***Quality Audit including
a Road Safety Audit,
DMURS Street Design
Audit, Cycle Audit, Walking
Audit, and an Access
Audit.***

Kilternan Village LRD

***Kilternan,
Co. Dublin***

Figure 3.2 – Street 3

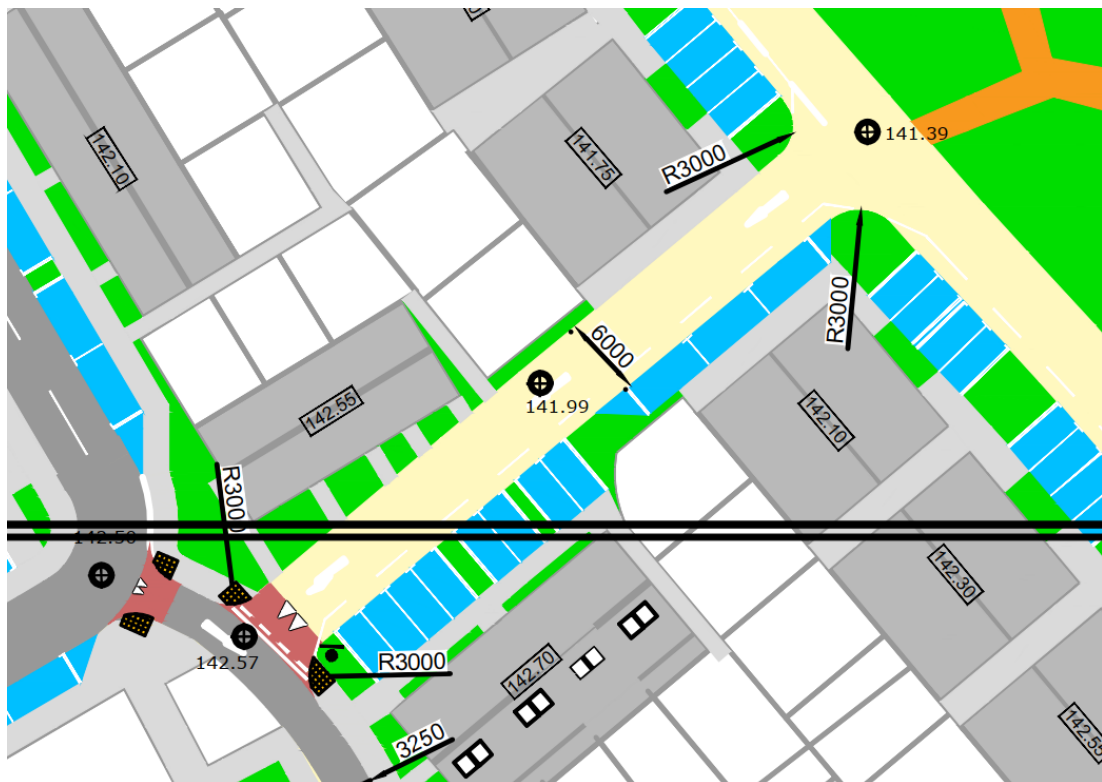
Problem

Street 3 is shown as a 6.0m wide, one-way road carriageway. Dashed lines are shown, which are presumed to indicate a pedestrian path / refuge. While it may be intended to provide contrasting materials (which are important tools for informing drivers of driving conditions) compared to a typical bitumen road surface, it is noted that narrow carriageways are one of the most effective design measures that calm traffic. The 6.0m wide road carriageway will likely encourage motorists to drive at excessive speeds, which may result in a collision with a pedestrian or cyclists using the road.

Shared surface streets can be very intimidating for visually or mobility impaired road users.

Recommendation

The road width should be reduced to **a maximum of 4.8m in width**. Verges (which can be hard landscaping) should be provided that act as refuge zones allowing pedestrians (in particular for visually or mobility impaired road users) to step on and off the carriageway to let cars pass. These verges should be 1.2m minimum, thus allowing for the appropriate width for cars turning from perpendicular parking.

3.2	Y	N	Vehicle tracking and movement has dictated that this short street section is design as shown. Space is required for larger vehicles to access and fpr so perpendicular cars to access / egress car parking space. The street. Changes shared street is design for very low speeds and very low volumes and the shared space will act as a part of the social aspect of the community fostering play etc.	Y

Figure 3.3 – Junction Street 3 - Street 2

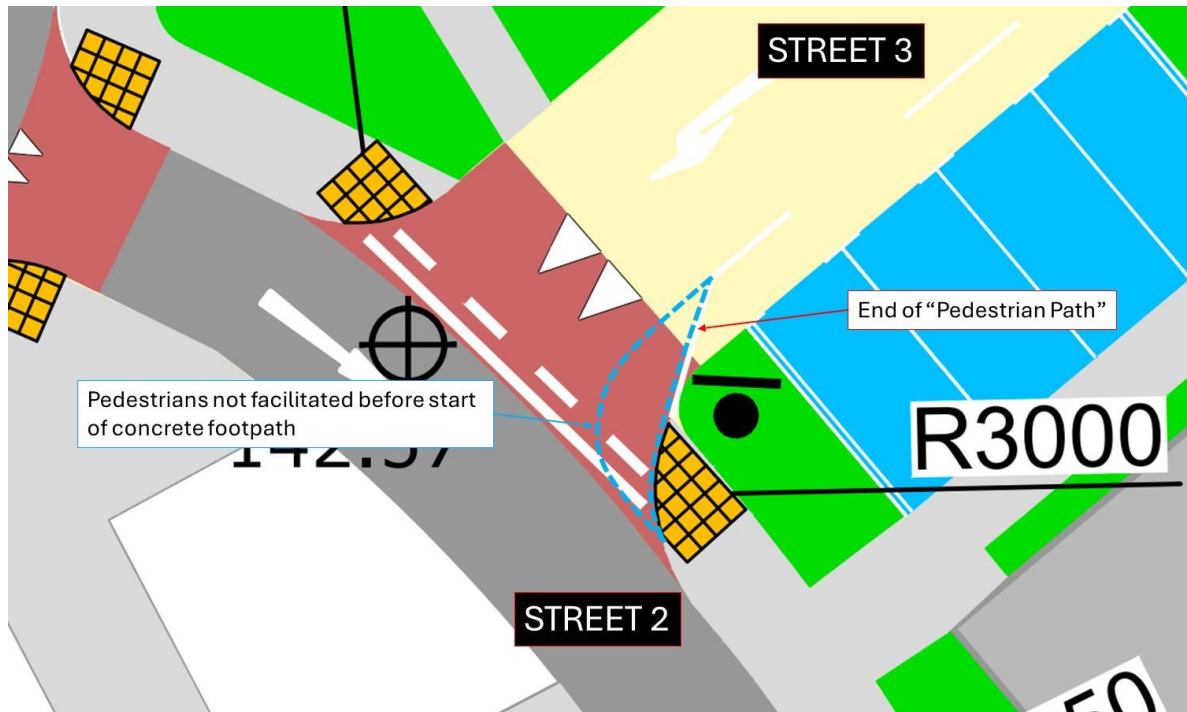
Problem

The 'Pedestrian Path' on Street 3, ends before the junction with Street 2. Pedestrians will be vulnerable to vehicles, in particular fast moving vehicles, turning left from Street 3. Furthermore, the radius appears larger than 3m.

Recommendation

The footpath on Street 2 should be extended back onto Street 3, so that pedestrians are not vulnerable to vehicles which are turning left from Street 3 onto Street 2.

Figure 3.5 – Public Lighting Locations

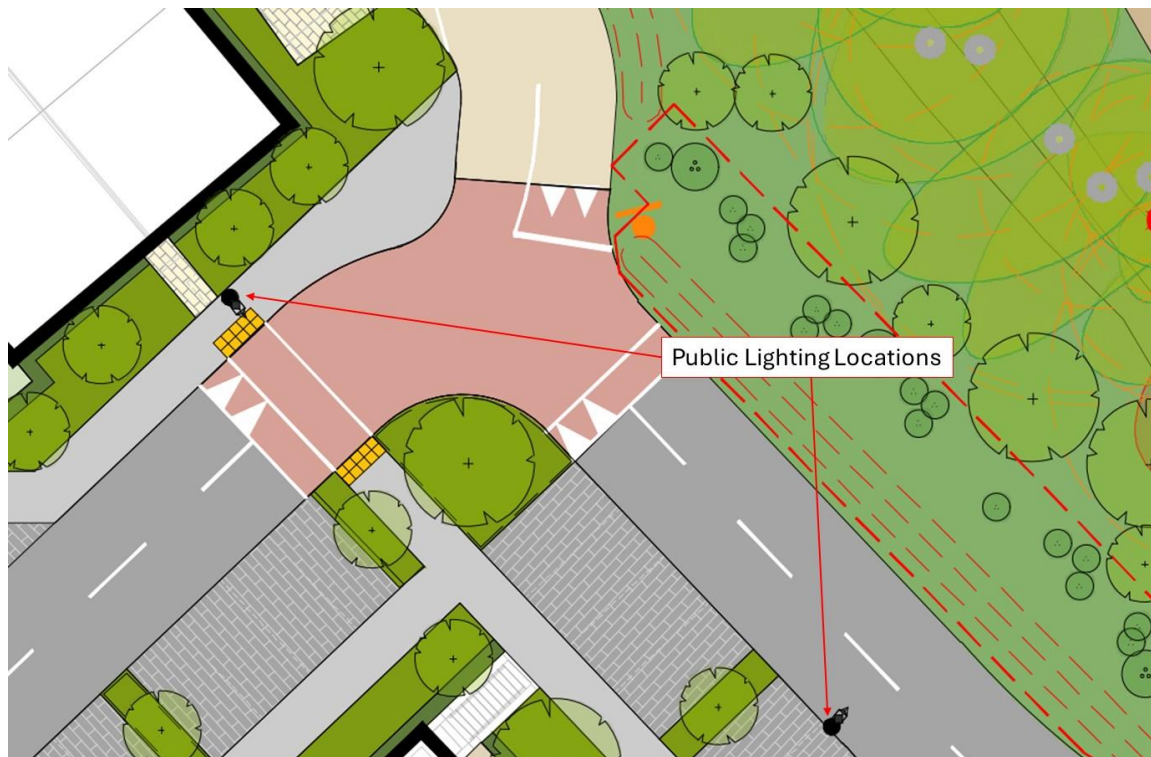
Problem

The Public Lighting are shown in locations where they will both obstruct both pedestrian and vehicle movements, which could lead collision with the poles resulting in injury.

Recommendation

A review of Public Lighting locations should be undertaken. Ideally, the public lighting is set back off the pedestrian footpaths and therefore not obstructing pedestrian movement.

Figure 3.7 – No Tie-In with Tactile Paving

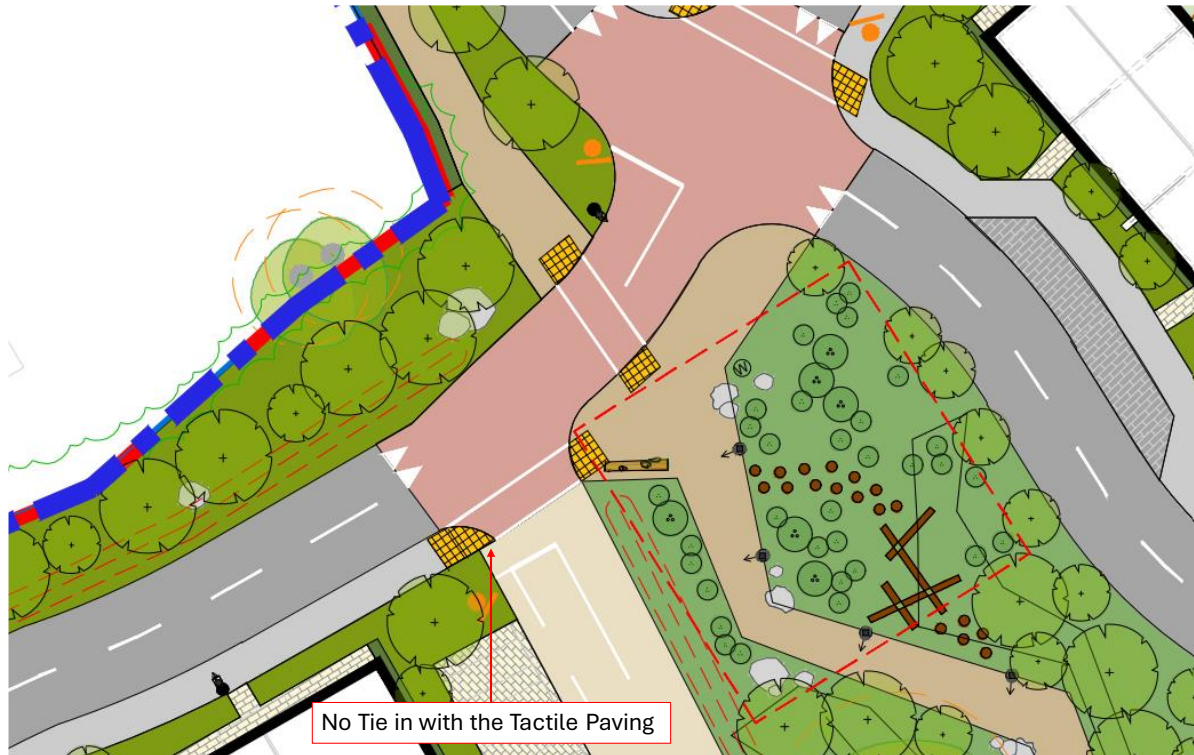
Problem

There are no tie-ins with the on-road pedestrian refuge and the tactile paving, with a stop line extending across the pedestrian refuge, resulting in a kerb protruding into the junction which could be a hazard for vehicles.

Recommendation

An appropriate tie-in should be provided.

Figure 4.1 – Example Street 11

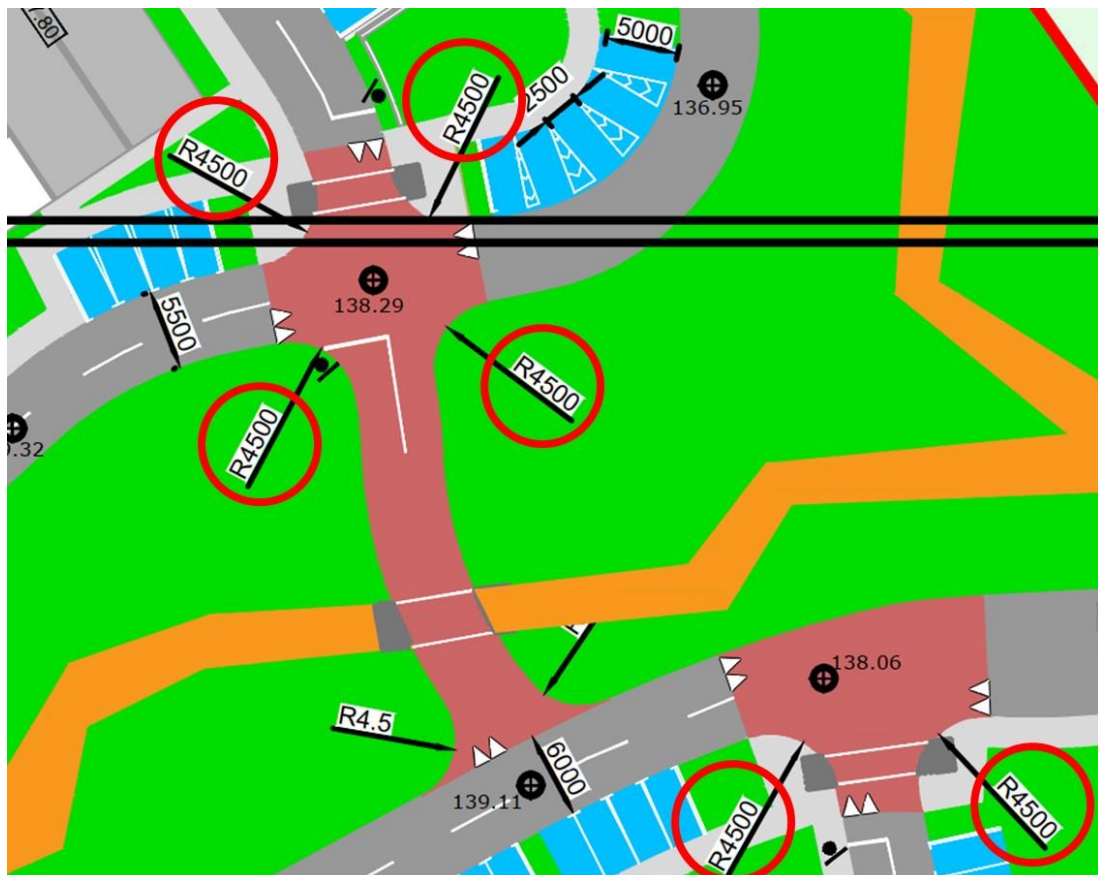
Problem

While the majority of junction corner radii within the LRD scheme are 3.0m, there are still some junction radii shown as 4.5m. Large corner radii could lead to excessive vehicle speeds, which could lead to a collision with a pedestrian crossing the road or a vehicle.

DMURS notes that “*where design speeds are low and movements by larger vehicles are infrequent, such as on Local streets, a maximum corner radii of 1-3m should be applied*”. All the roads within the LRD are Local Streets.

Where the LRD connects into the external road network, such as the junctions on the Enniskerry Road, the Glenamuck Road, and the Glenamuck Road Distribution Road, the corner radii can be increased.

Recommendation

The corner radii at the junction should be reduced to accord with DMURS.

Figure 5.2 – Enniskerry Road Access

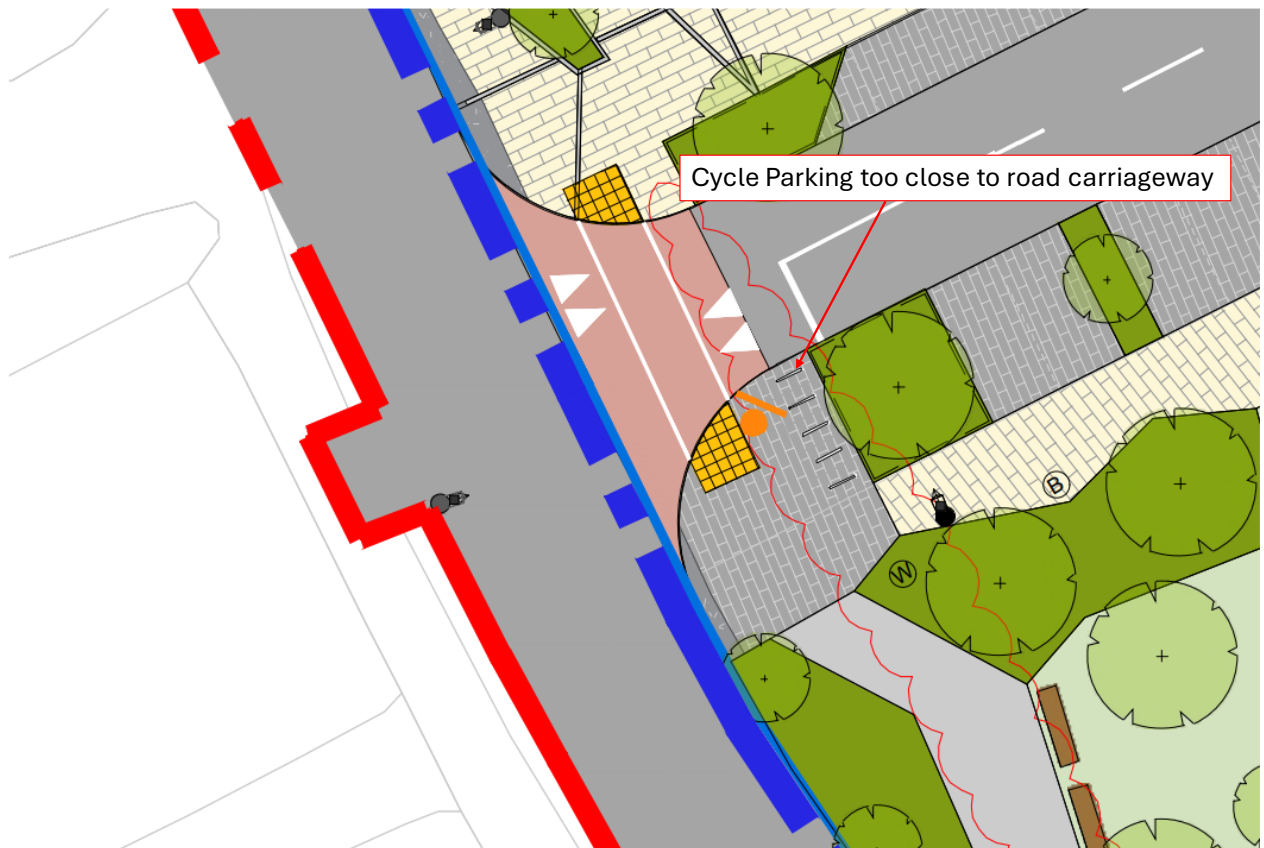
Problem

The last cycle parking space is located too close to the road carriageway. There is a risk that a pedestrian will have to step out onto the road carriageway when locking or unlocking their bike, putting them at risk with a collision with a passing vehicle.

Recommendation

The cycle parking space should be relocated.

Figure 6.1 – Proposed Pedestrian Crossings

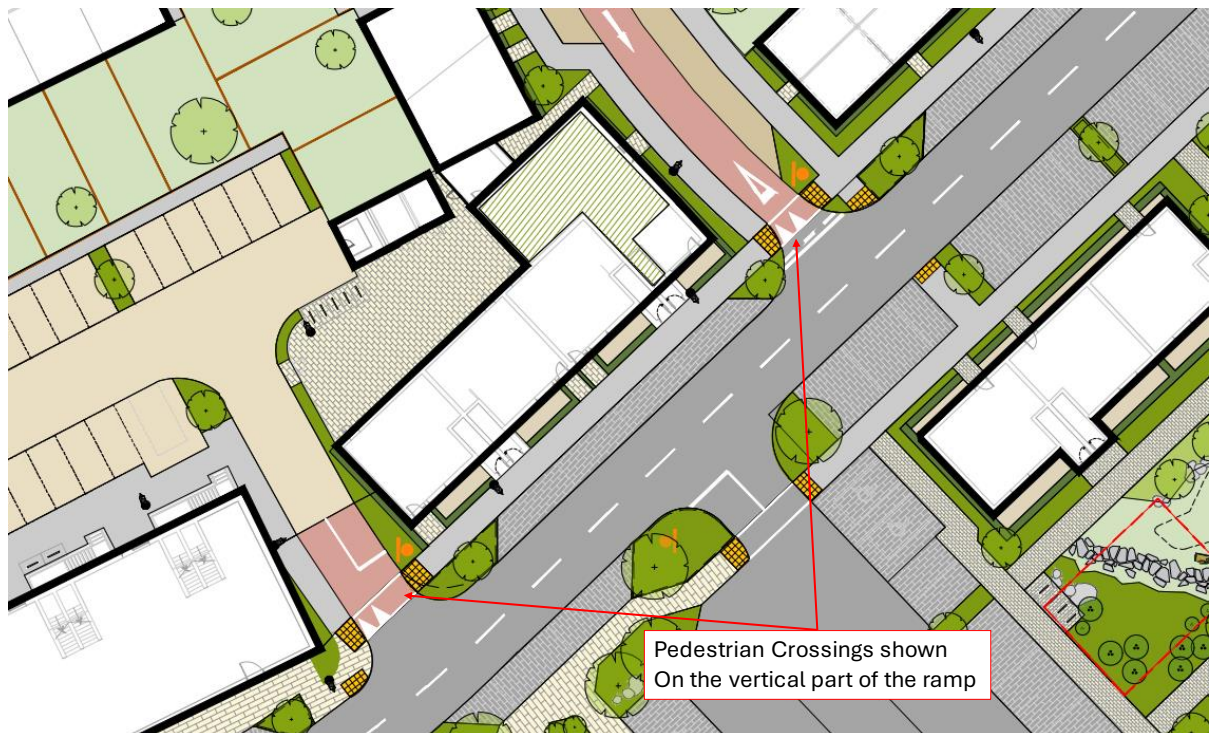
Problem

The pedestrian crossings are shown on the vertical part of the ramps. This could lead to pedestrians tripping or falling as a change in slope is not anticipated.

Recommendation

The proposed ramps should be brought forward so that pedestrians are crossing on the flat part of the ramp.

Figure 6.4 – Raised Table

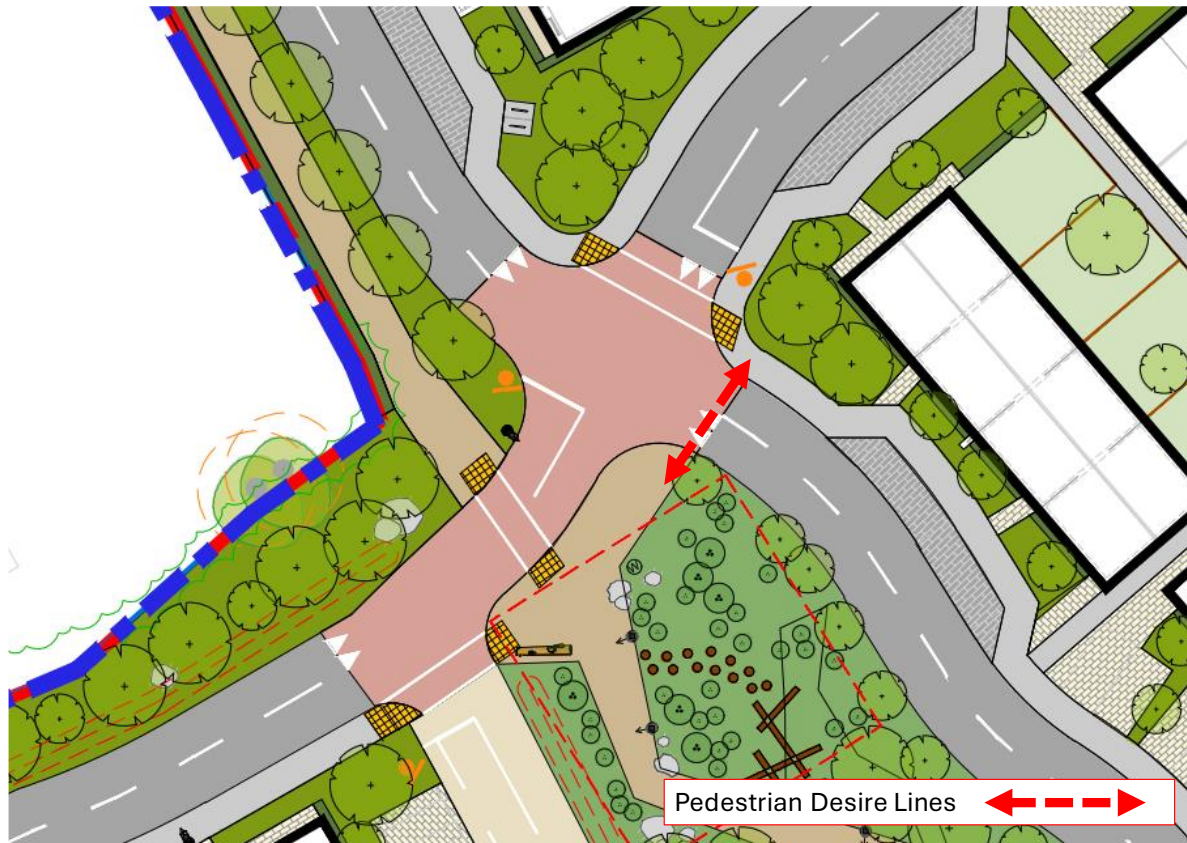
Problem

A desire line will exist between the landscaped area to the south and the residential developments to the north. No crossing point has been proposed on the eastern side of the junction, which will make it more difficult for the visually impaired and those using wheelchairs to cross at this location.

Recommendation

A pedestrian crossing, including a dropped kerb and tactile paving should be provided on the eastern side of the junction.

Figure 7.1 – Pedestrian Desire Lines on GLDR

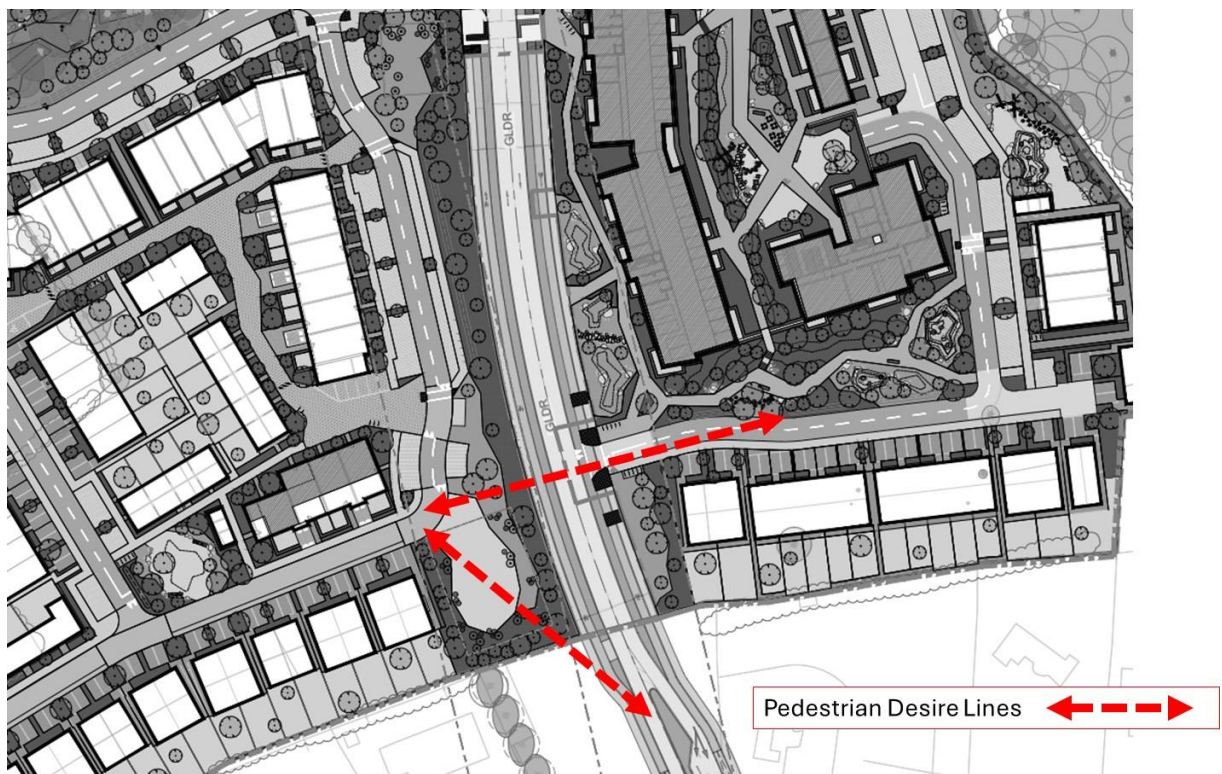
Problem

A desire line will exist between the 2no. housing developments across the Glenamuck Link Distribution Road, and for those pedestrians wishing to travel south. No crossing point has been proposed across the GLDR. In addition, pedestrians will likely wish to cross the grassed open space rather than using the longer proposed footpath at the entrance/exit to the north. A lack of hard standing on the desire line could lead to slips and falls in the grassed areas (particularly in winter).

Recommendation

It is recommended that an appropriate safe crossing point be provided, including a footpath connection on the desire line.

Figure 7.3 – Pedestrian Plaza beside the Enniskerry Road

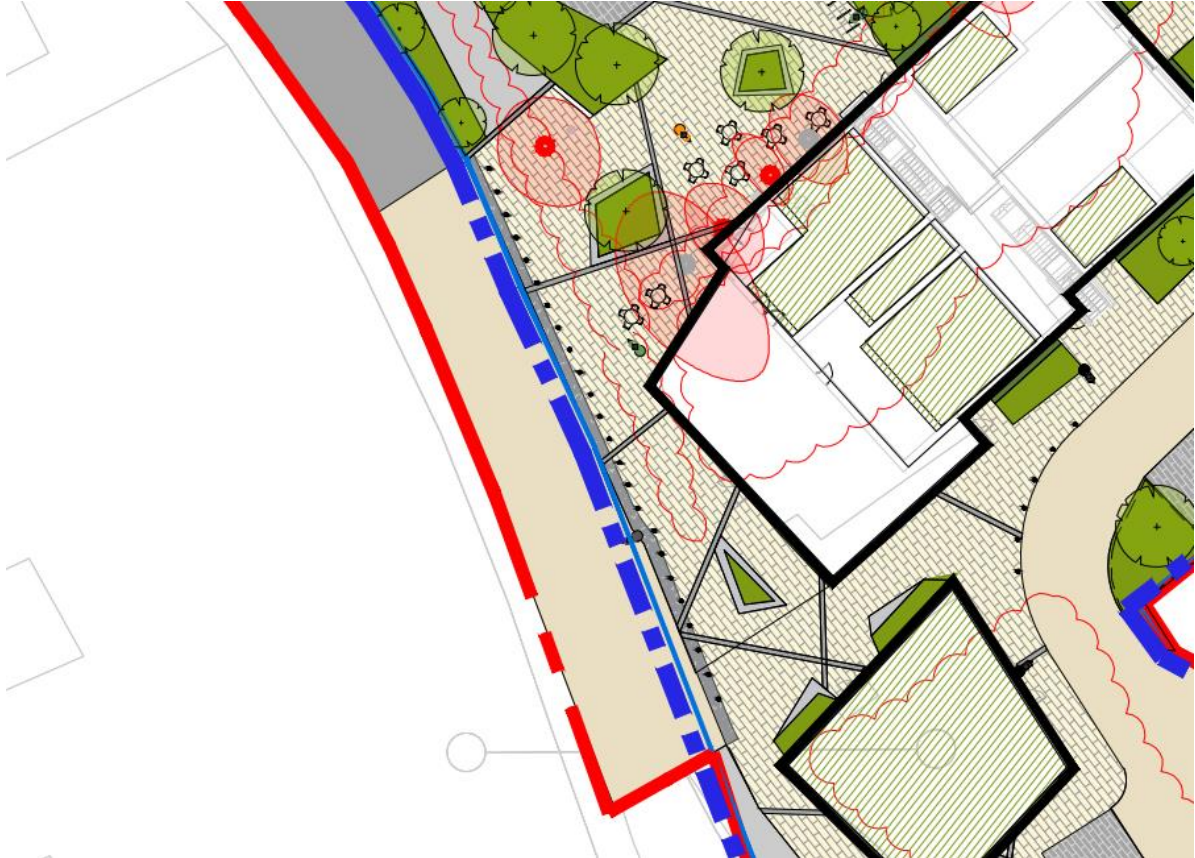
Problem

It is unclear what is proposed on the road carriageway beside the pedestrian plaza.

Recommendation

A raised table should be provided to ensure slower speeds passed the pedestrian plaza.
Sharks teeth to be provided etc.
